PROPOSAL, CONTRACT, BOND AND SPECIFICATIONS

E Main Street and South Hancock Street Assessment District - 2025

CONTRACT NO. 8784

1. REVISED SHEETS: D-1, D-2, D-6, D-7, INT-2, INT-3, INT-7, P-1, P-2, P-4, P-6, U-1 - U-7, U-12, W-1, W-2, W-5 - W-7, E-1 - E-9, PM-8, X-15, AND X-16.

TYPICAL SECTION
E. MAIN ST.
(S. WEBSTER ST. TO S. BUTLER ST.)

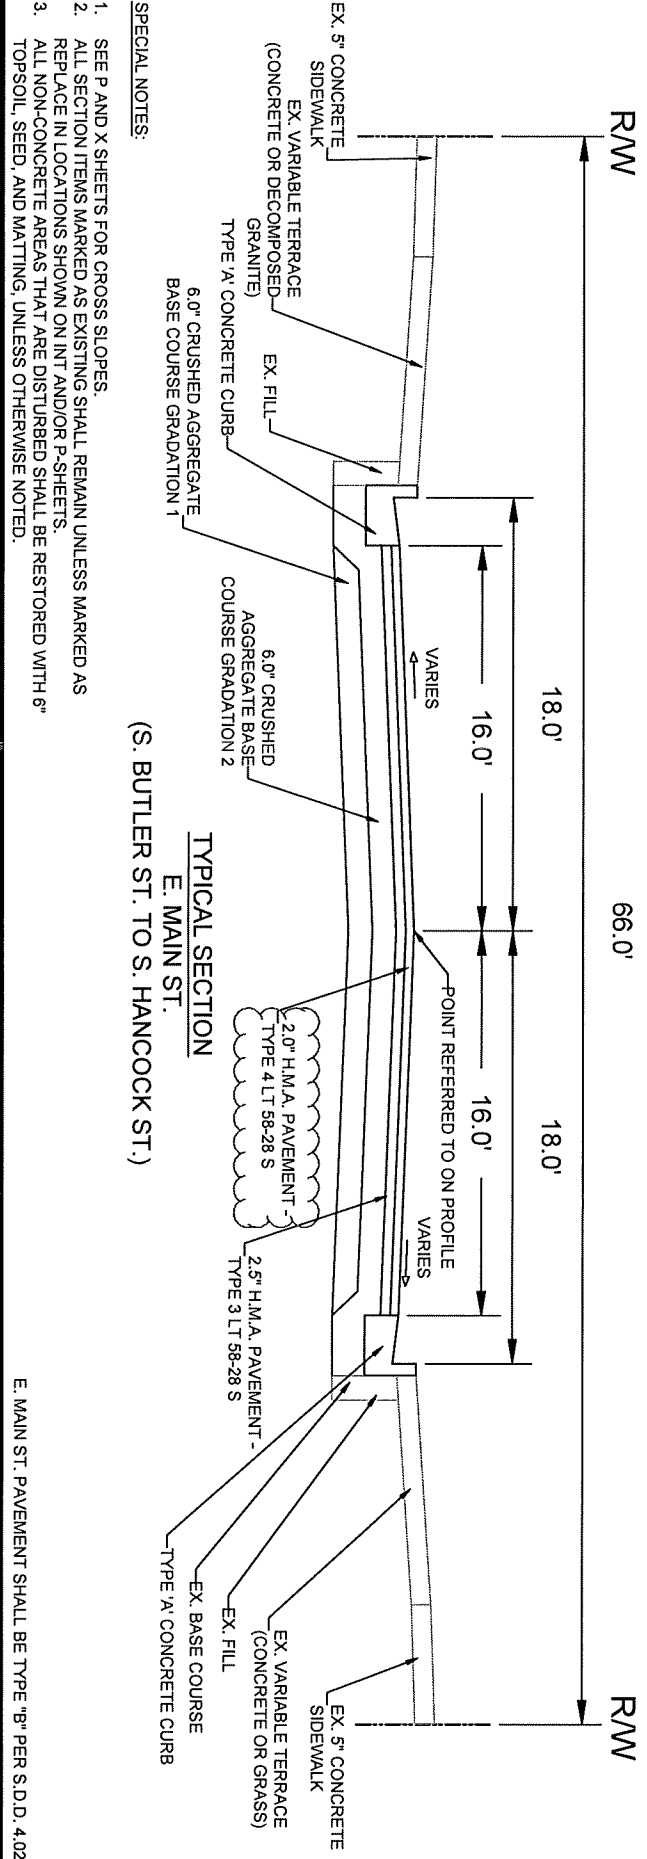
ADDENDUM 1 - 6/24/2025
CORRECTED SURFACE MIX TYPE FROM
"MT" TO "LT".

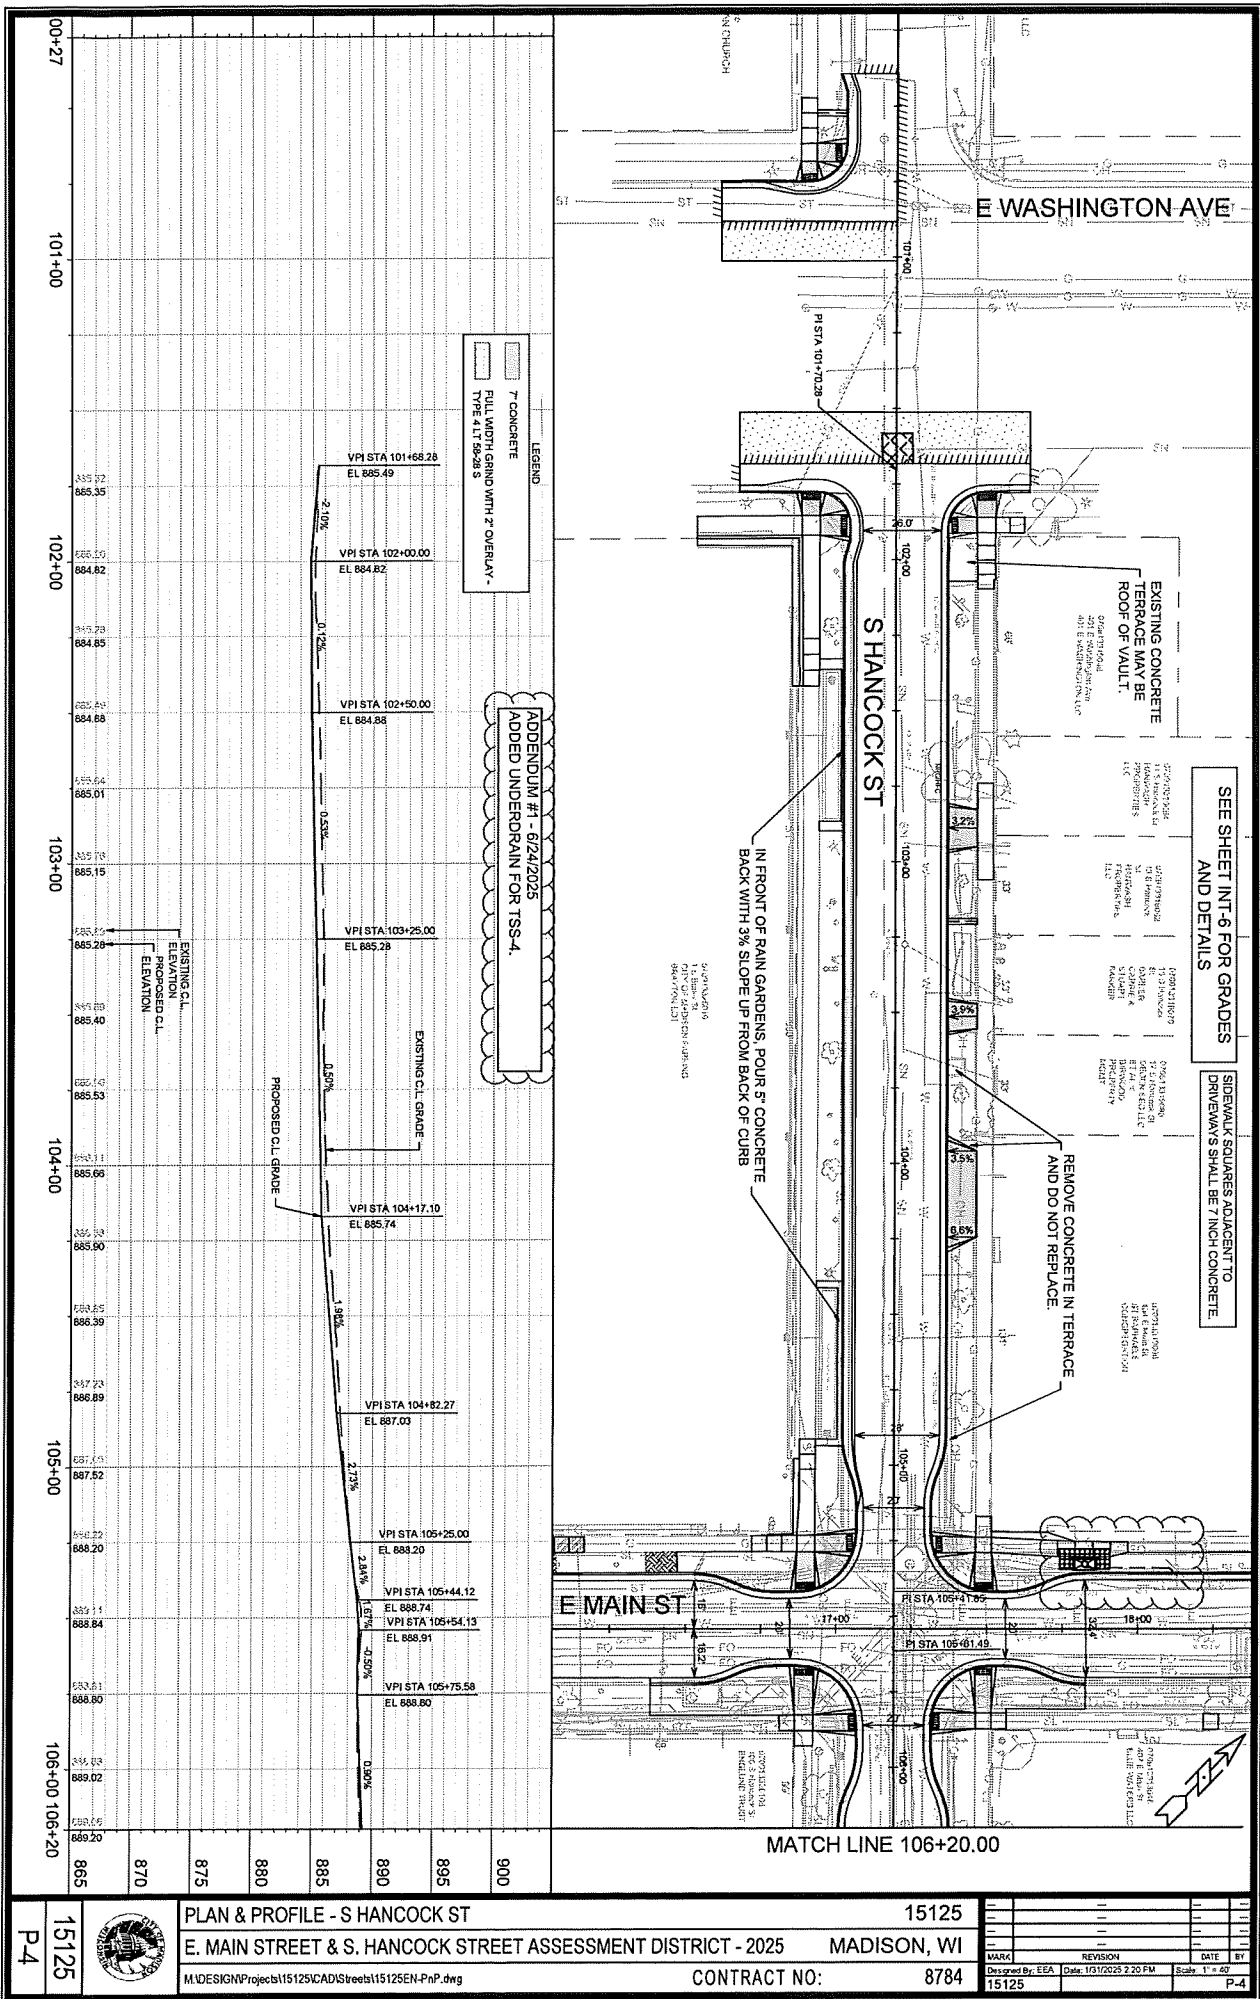
ADDENDUM 1 - 6/24/2025
1. INCREASED CURB REMOVAL/REPLACEMENT ON
SOUTHWEST SIDE OF S. HANCOCK STREET.
2. ADJUSTED CL PROFILE START POINT AND
FOLLOWING VPI.

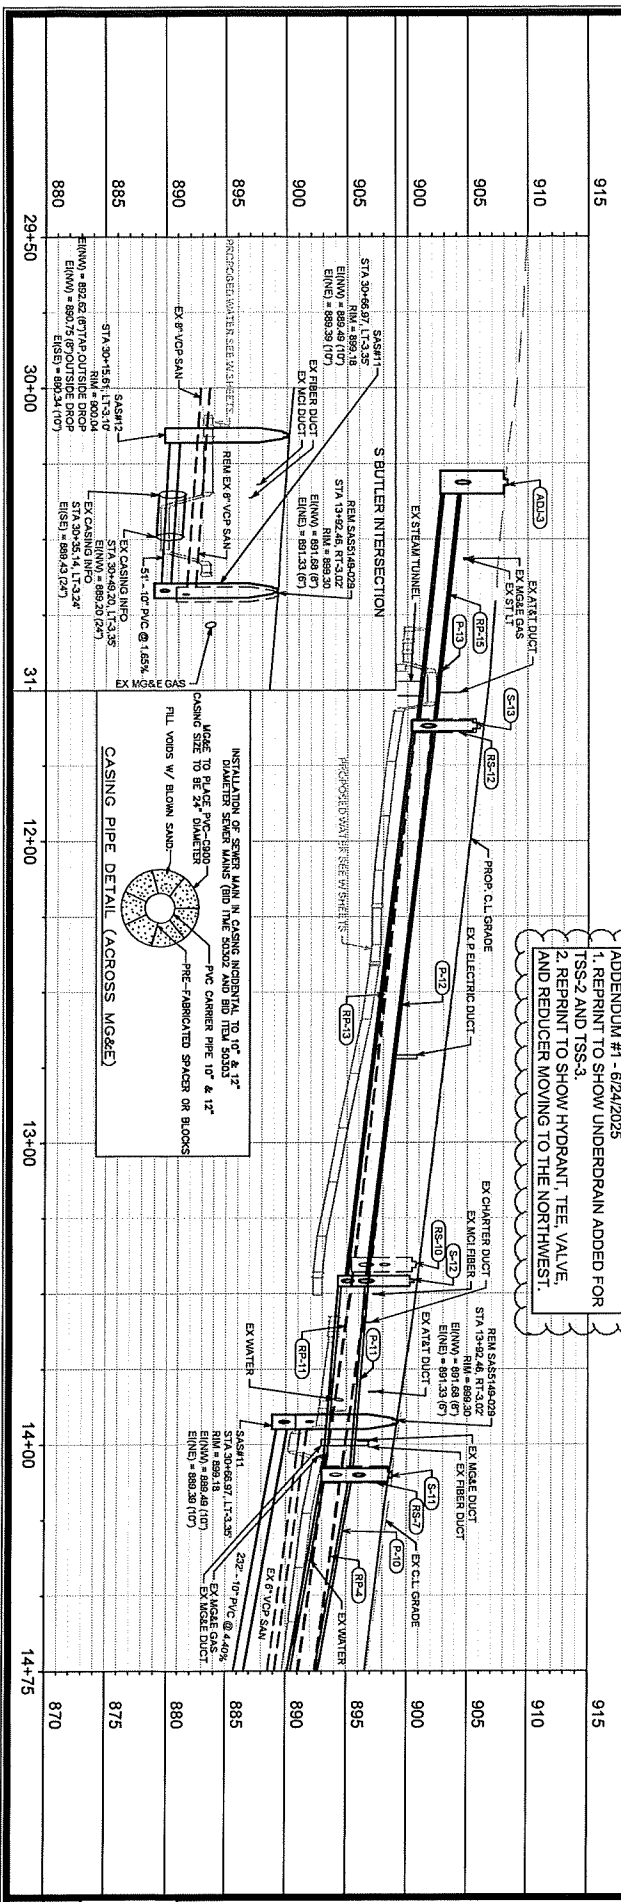
1. REPRINT TO SHOW UNDERDRAIN ADDED FOR TSS-2 AND TSS-3.
2. REPRINT TO SHOW HYDRANT TEE VALVE, AND REDUCER MOVING TO THE NORTHWEST.

S HANCOCK ST - PLAN & PROFILE E. MAIN STREET & S. HANCOCK STREET ASSESSMENT DISTRICT - 2025 MADISON, WI M:\DESIGN\Projects\15125\CAD\Sewers\15125SWR-PipeNetwork.dwg	15125 CONTRACT NO: 8784 ADDENDUM 1 REVISION DATE: 6/24/2025 10:30 AM Scale: 1" = 40' U-4
---	--	---

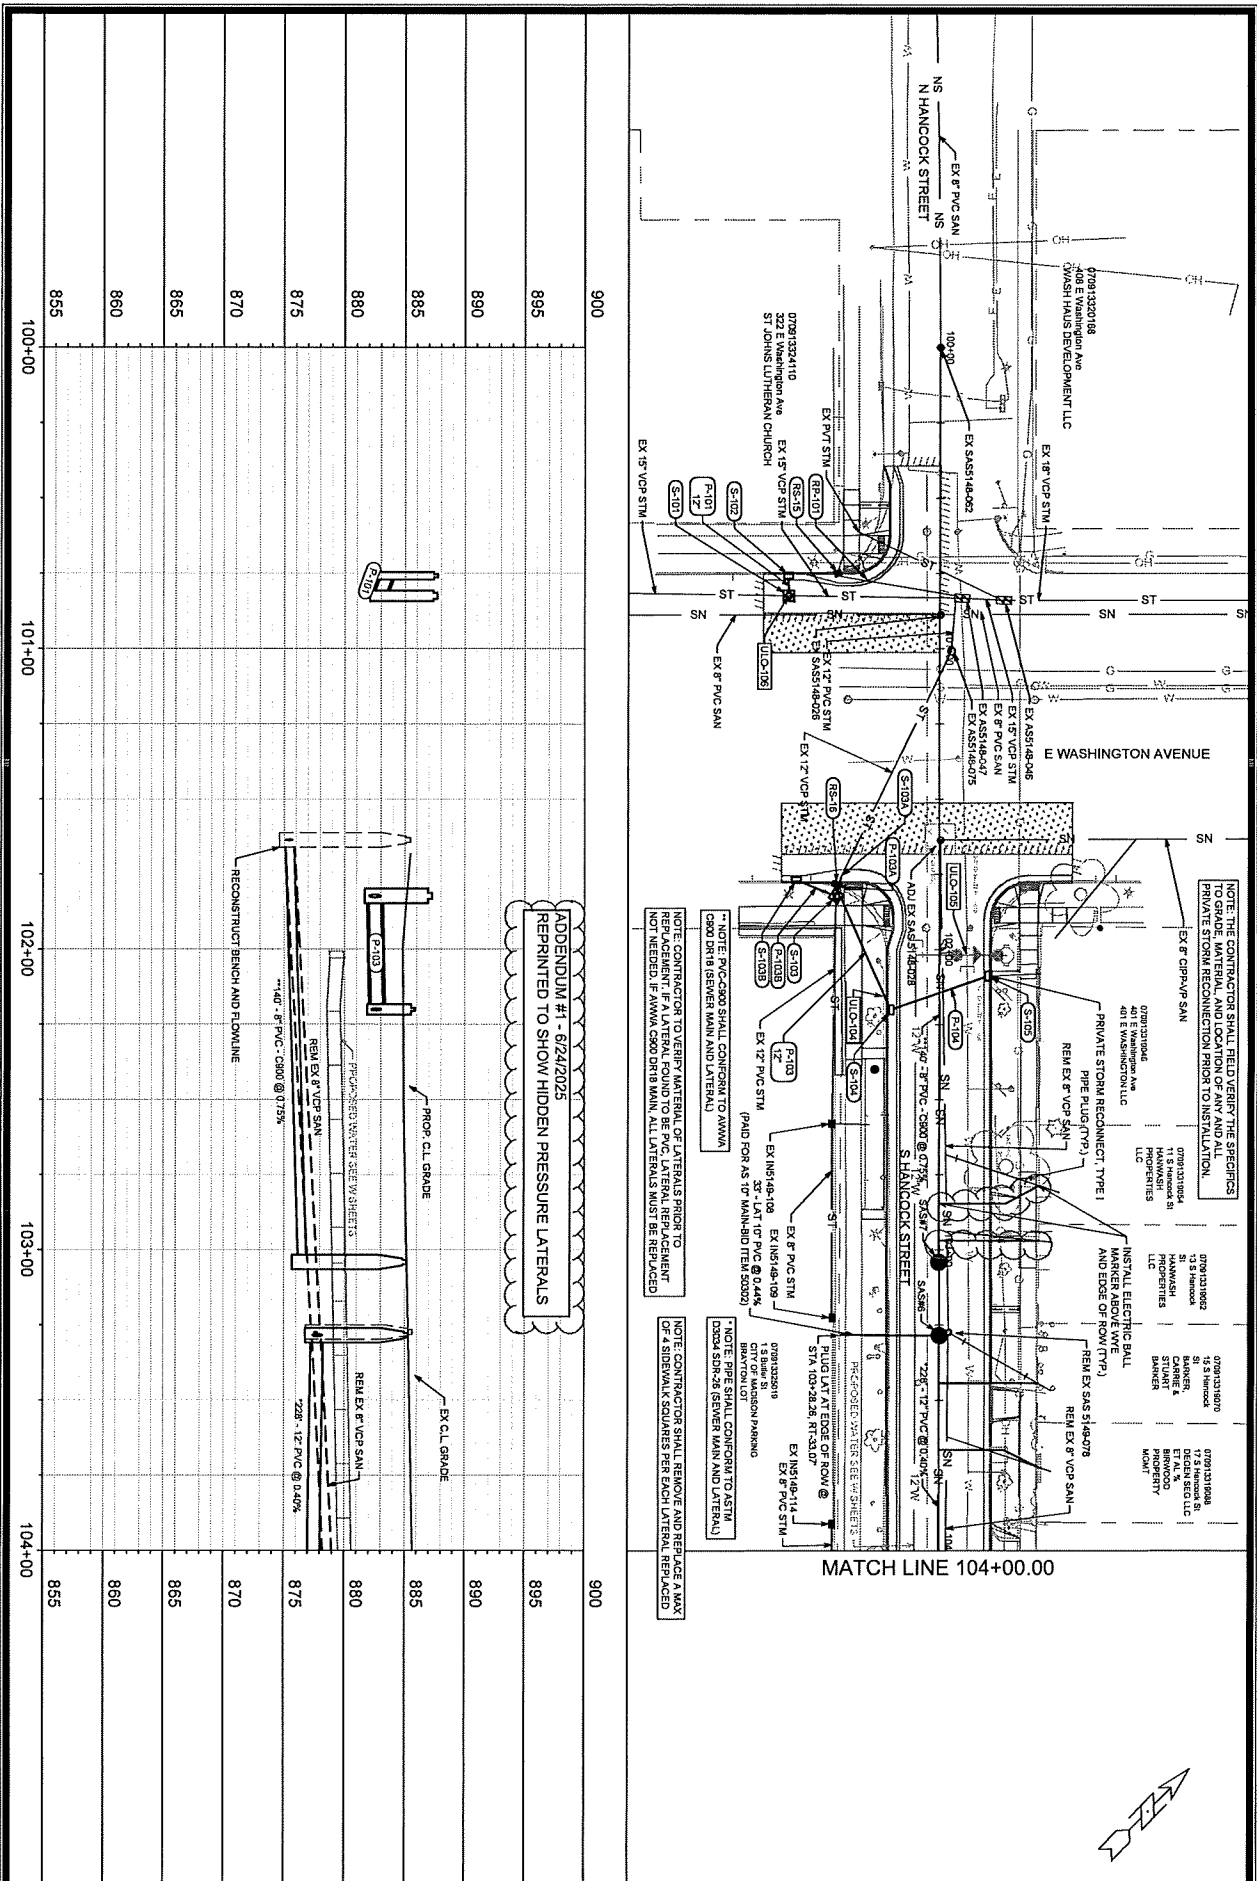
1. REPRINT TO SHOW UNDERDRAIN ADDED FOR TSSS
2. CHANGED EX SAS 5249-038 FROM ADJUST TO REMOVE AND REPLACE WITH SAS #22.
3. REDUCED THE INSTALLED LENGTH (6') OF CASING FOR 10" PVC LATERAL AT SAS #10.

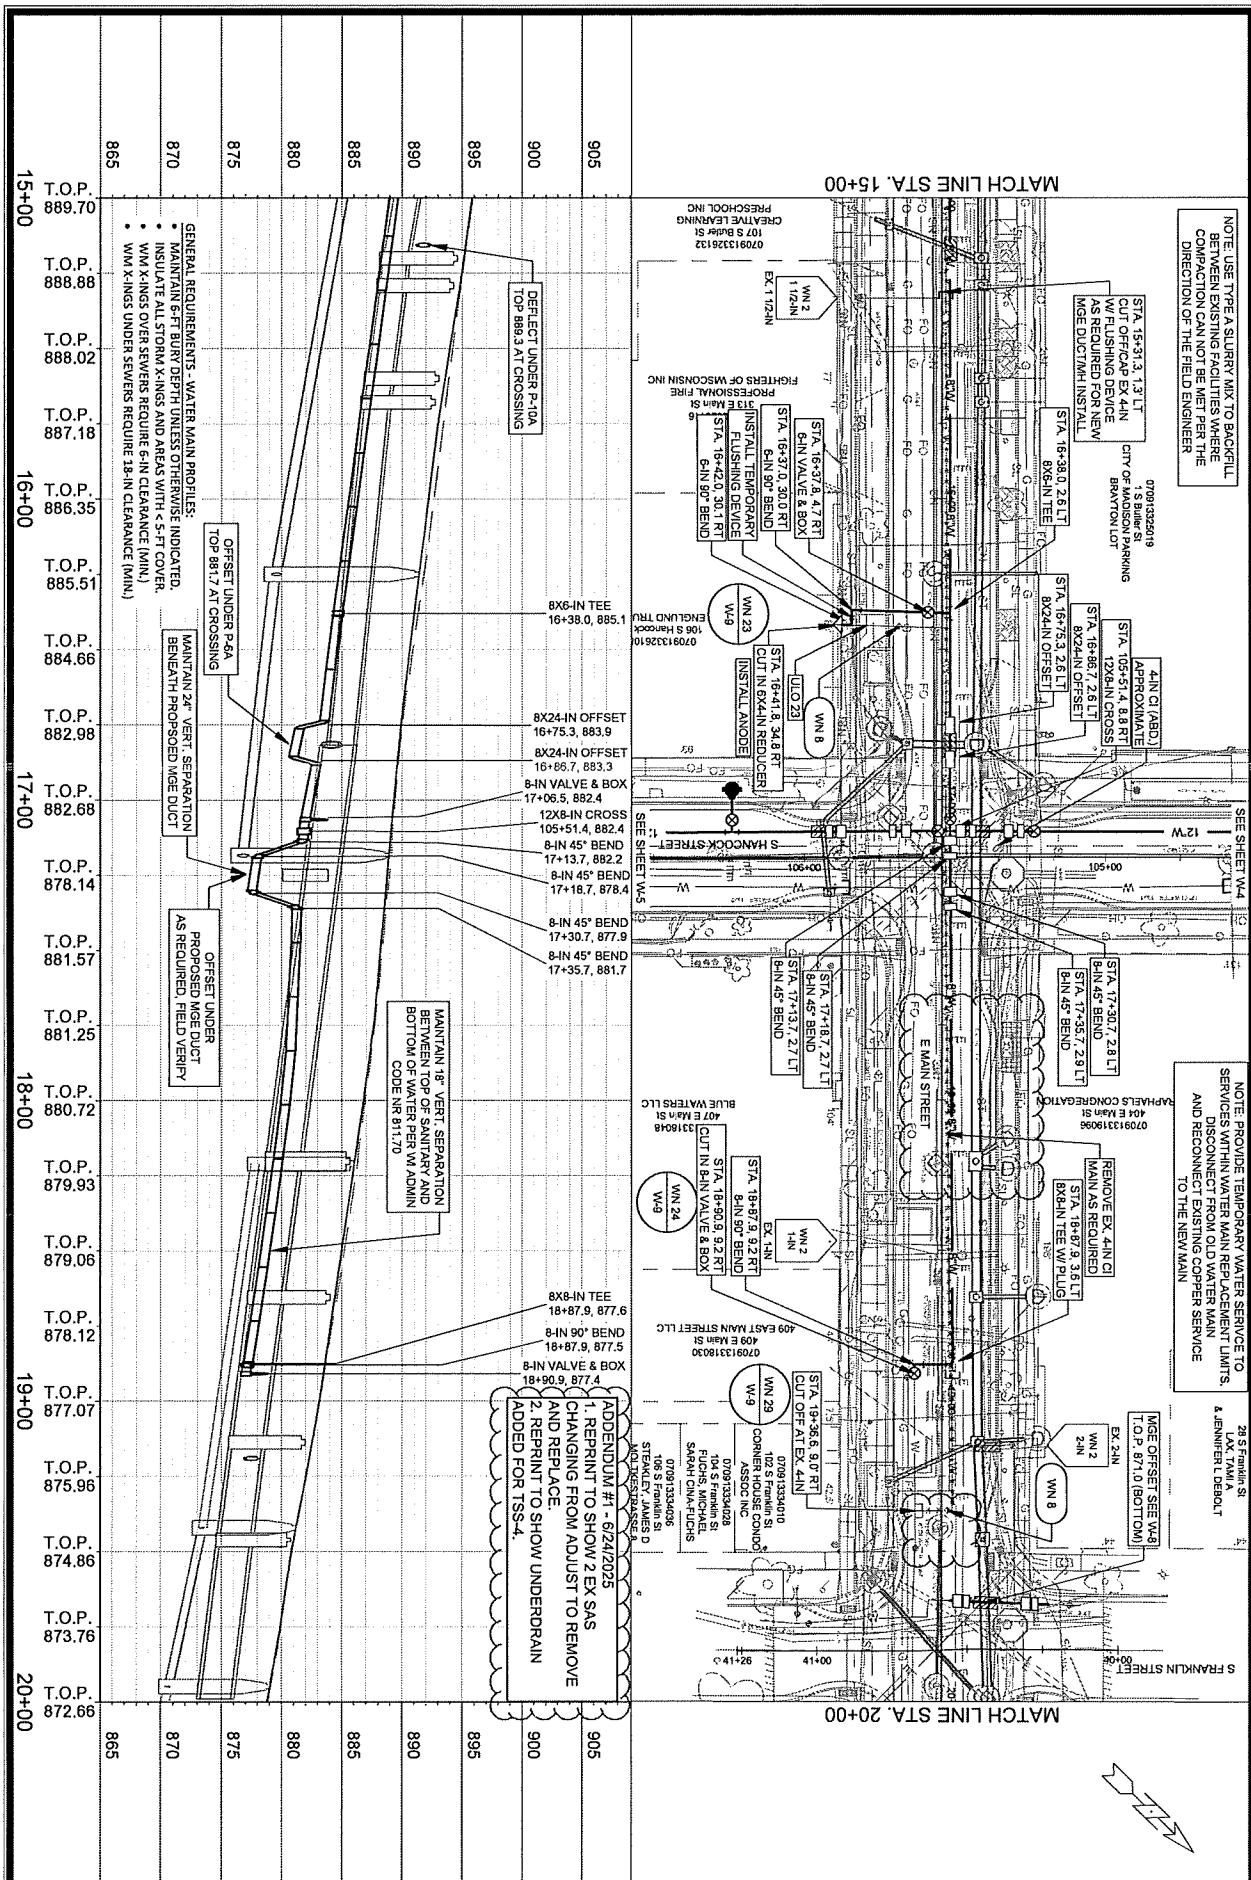
ADDENDUM #1 - 6/24/2025
1. REPRINT TO SHOW 2 EX S/S
CHANGING FROM ADJUST TO REMOVE
AND REPLACE.
2. REPRINT TO SHOW UNDERDRAIN
ADDED FOR TSS-4.
